# Service Advisory

CC-429

Models Affected: 1525 (13A-221F100); 1527 (13A-241G100) and 1529 (13A-261H100)

Subject: P/N 725-1426 STARTER SOLENOIDS

FIGURE 1

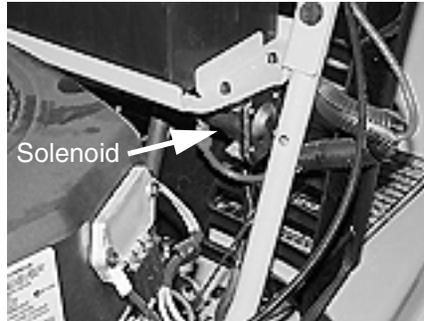
1. Turn key to the OFF position and remove from ignition switch.
2. Place parking brake in the ON position.
3. Locate the battery and disconnect the NEGATIVE (Black) wire first, followed by the POSITIVE (Red) wire next.
4. Refer to Figure 1 on Page 2. The solenoid is located mounted under the battery on the left side of the battery bracket. Left and right is from the operator's position.

FIGURE 2

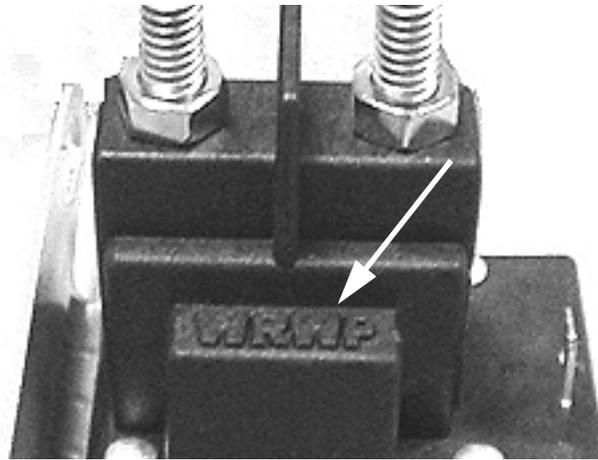
5. Locate the solenoid for unit being repaired.
6. Observe and record the connection location of the following wires to the solenoid. The POSITIVE (Red) and NEGATIVE (Black) wires coming from the battery, the heavy red wire from the harness, the green wire from the harness and the orange/white wire to the solenoid's flat blade terminal for reconnection in a later step. Dependent of tractor model the NEGATIVE (Black) battery wire may be connected at the frame and not the solenoid.
7. Depending on the solenoid location either remove the solenoid from the frame first then disconnect the wires from the solenoid or disconnect the wires from the solenoid and then remove the solenoid from the frame.
8. Retain the old solenoid for warranty.

9. Reversing the removal instructions above, install a supplied replacement solenoid ( P/N 725-1426). Make sure the green wire from the harness is against the metal bracket of the solenoid. Tighten mounting bolts.
10. Reconnect the remaining wires removed in Step 7 above in accordance with the locations recorded in Step 6.
11. Torque the 1/4"-20 nuts on the two 1/4"-20 copper studs to 20-28 inch-pounds.
12. Double check the installation against that was recorded in Step 6.
13. Replace the battery tray and battery if removed in Step 4.
14. Connect the POSITIVE (Red) wire to the battery first. Then connect the NEGATIVE (Black) wire to the battery.
15. Test the installation by performing the START TEST as outlined in the START TEST section above.
16. This concludes the solenoid test and replacement.
